# PCN-20190717 TE0720-03-1CFA-S Carrier Hardware Revision Change

<b>Company</b>	Trenz Electronic GmbH
<b>PCN Number</b>	PCN-20190717
<b>Title</b>	TE0720-03-1CFA-S Carrier Hardware Revision Change
<b>Subject</b>	Carrier Hardware Revision Change
<b>Issue Date</b>	2019-07-17

This change affects TE0720-03-1CFA-S, which includes carrier TE0703. This carrier is subject to a hardware revision change from TE0703-05 to TE0703-06.

## #8 Routing lenght of differential pairs B34\_L17, B34\_L15, B34\_L21, B34\_L13, B34\_L10, B34\_L20 changed

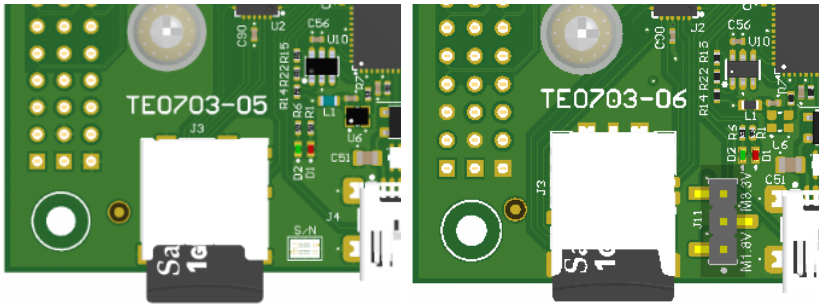
**Type:** Layout change

**Reason:** Other changes and limited space on PCB

**Impact:** Applications with exact timing requirements on these IOs have to be checked and if necessary adjusted
